Additional Information for XCN08014: Q&A

XTP036 (v1.0) October 20, 2008

Q1. Why is Xilinx standardizing to a 2-layer package substrate for Spartan-3A FT256 product?

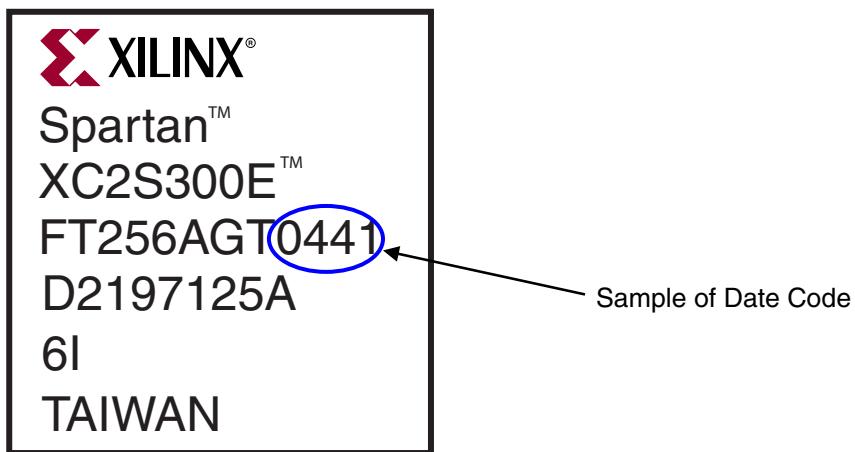
Q8. How do I know whether I have the 2-layer substrate after January 10, 2009?

- A. Xilinx will update this document with the exact cutover date codes to 2-layer substrates. The Date Code can be found on the package top mark, as indicated below:
